DEVELOPMENT REVIEW BOARD REPORT

MEETING DATE: September 7, 2006

| CASE NUMBER/ PROJECT NAME | 17-DR-2006 68th Street and Thomas Road | | |
| REQUEST | Request approval of a site plan, landscape plan and elevations for a office/retail building. | | |

SITE PLAN

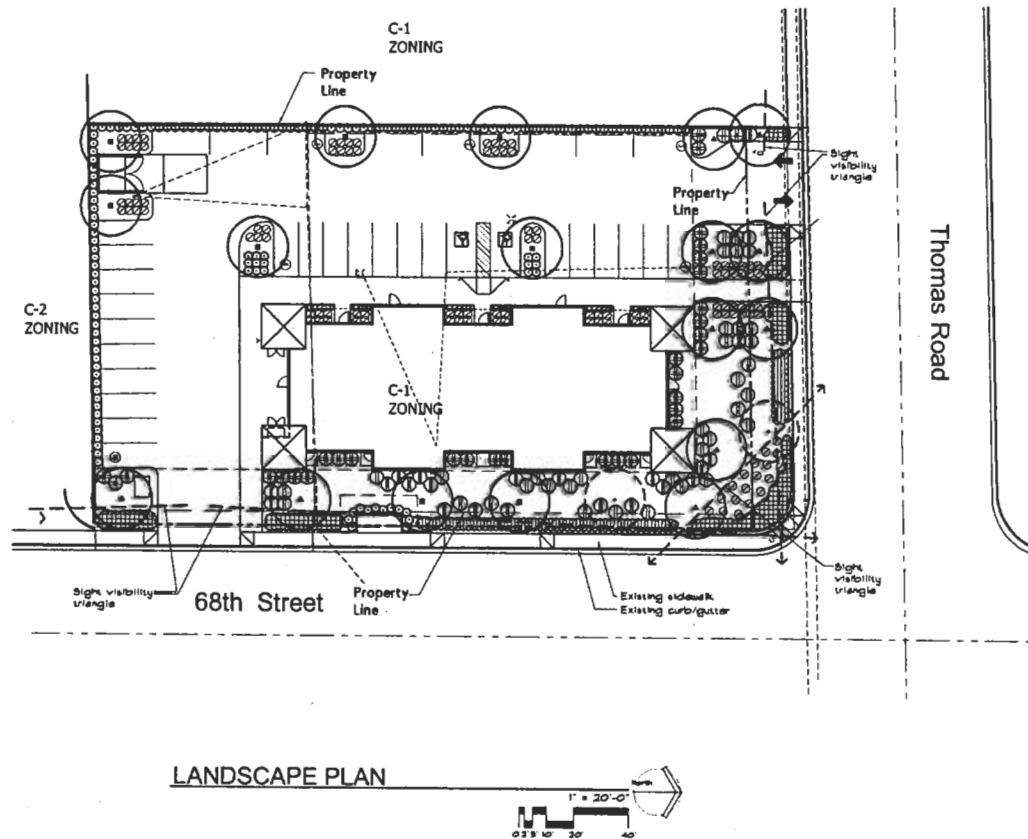
11. *A 3-foot high screen wall shall be provided to screen the parking lot adjacent to North 68th Street south of the drive aisle. This wall shall be located at the 20 foot setback line.*
12. *A 3-foot high screen wall shall be provided to screen the parking lot adjacent to East Thomas Road on the east and west side of the drive aisle. This wall shall be provided at the 20-foot setback line.*
13. *The electrical transformer shall be located adjacent to the trash enclosure.*

29. The developer shall eliminate the northern most driveway on North 68th Street.

30. The developer shall provide a minimum parking-aisle width of 24 feet.
31. The developer shall provide internal circulation that accommodates emergency and service vehicles with an outside turning radius of 45 feet and inside turning radius of 25 feet.

PHOTOMETRICS SITE PLAN

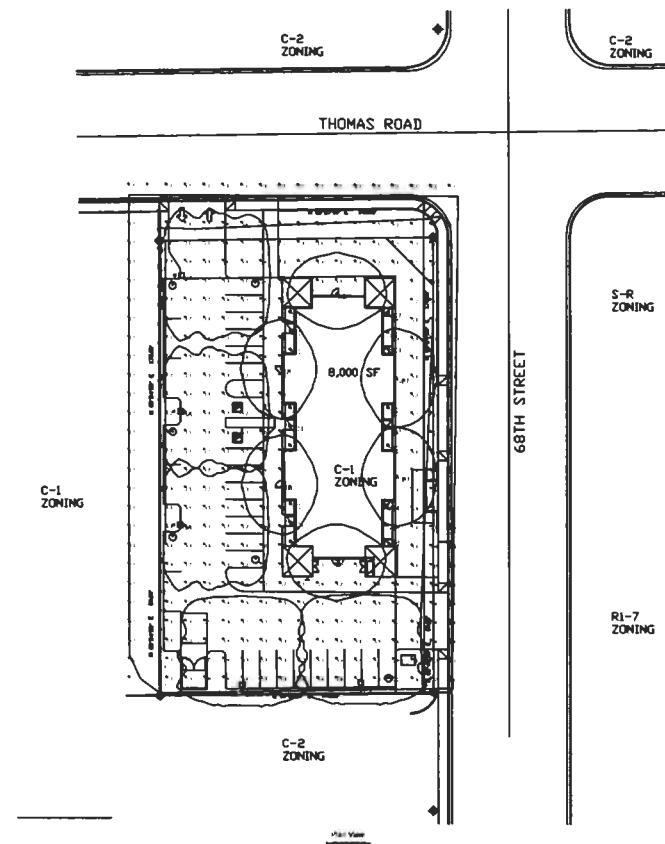
18. *All exterior luminaires shall meet all IESNA requirements for full cutoff, and shall be aimed downward and away from property line except for sign and parking lot canopy lighting.*
19. *The individual luminaire lamp shall not exceed 250 watts.*
20. *The maximum height from finished grade to the bottom of the any exterior luminaire shall not exceed 20 feet.*
21. *All exterior light poles, pole fixtures, and yokes, shall be a flat black or dark bronze.*
22. *Incorporate into the project's design, the following:*

- a. *The maintained average horizontal illuminance level, at grade on the site shall not exceed 2.0 foot-candles.*
- b. *The maintained maximum horizontal illuminance level, at grade on the site, shall not exceed 8.0 foot-candles. All exterior luminaires shall be included in this calculation.*
- c. *The initial vertical illuminance at 6.0 foot above grade, along the entire property line (or 1 foot outside of any block wall exceeding 5 foot in height) shall not exceed 0.8 foot-candles. All exterior luminaires shall be included in this calculation.*

- d. All luminaires shall be recessed or shielded so the light source is not directly visible from property line.
- e. *The applicant shall return for a staff approval of the light fixtures identified on the elevations. This fixture shall be decorative in appearance.*
